## Notice of Local Traffic Committee Meeting

## ROAD SAFETY AUDIT

Existing School Zone  
Wollongbar Public School, Simpson Avenue

**Attachment 3:** General Comments and Recommendations

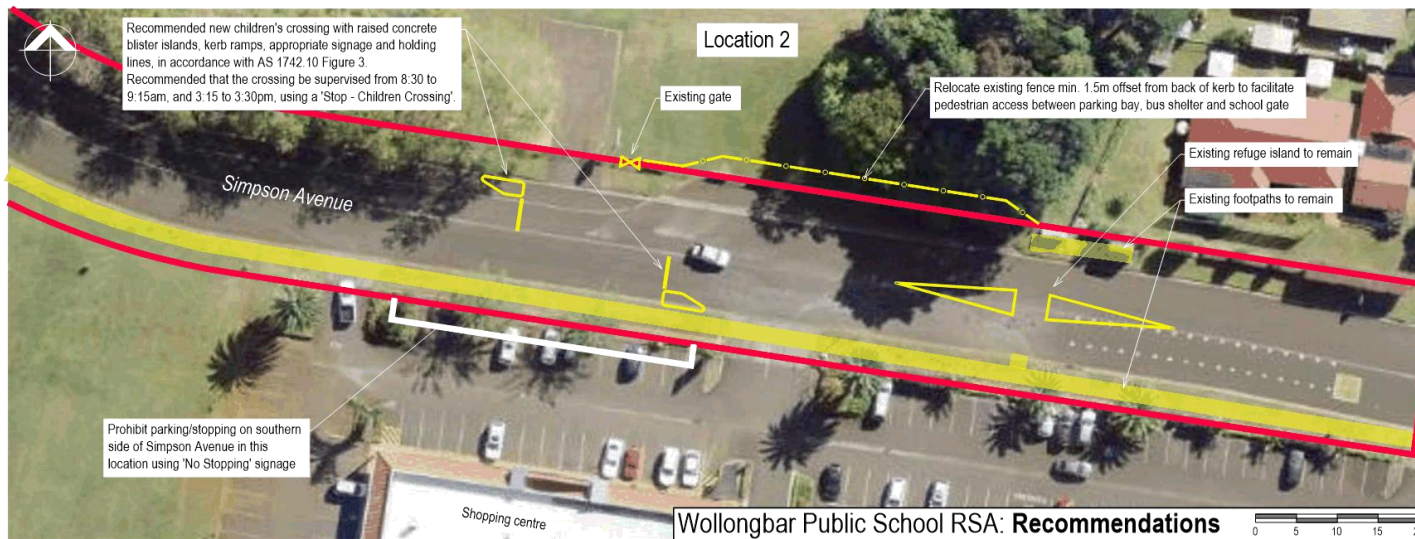
- The school zone appears to be in the correct location with good signage and pavement markings.
- The formal children's crossing in Location 1 works well when supervised. Without a supervisor, it appears to be underutilised and less safe for users. Providing a supervisor between 8:30am and 9:15am is recommended.

- It was noted that the crossing supervisors observed during the afternoon audit did not have a 'Stop – Children Crossing' sign. Such a sign would increase the visibility for vehicles approaching over the crest from the north by adding height when pedestrians are crossing.

- White painted pavement markings are recommended to designate priority at the driveway entrance to the school staff parking area.
- The location of the pedestrian refuge in Location 2 appears to be chosen to serve pedestrians crossing between the shopping centre or tavern on the southern side of Simpson Avenue and the bus shelter on the northern side. However, the location is too far from the school gate in Location 2 to be sufficiently convenient to serve the majority of pedestrians associated with the school. Relocating or extending the refuge to align with the school gate would cause problems for right-turn manoeuvres into and out of the driveways within Location 2. Thus it is recommended that a children's crossing is established at the school gate, similar to the crossing at Location 1, including two small blister islands and appropriate signage and pavement markings.

- Relocating the existing school fence to be further offset from the parallel parking bay/bus zone in Location 2 would allow for the construction of a footpath between the bay and the fence.

- Prohibiting parking on the southern side of Simpson Avenue along the 40m stretch between the western and central driveways to the shopping centre/tavern (or part thereof) is recommended to significantly improve the available sight distance for vehicles exiting the shopping centre/tavern from the western-most driveway.

- Many vehicles were observed making U-turns over the double barrier centreline during the morning and afternoon audits in both locations. Parents/guardians should be reminded that such behaviour is prohibited under the NSW road rules.
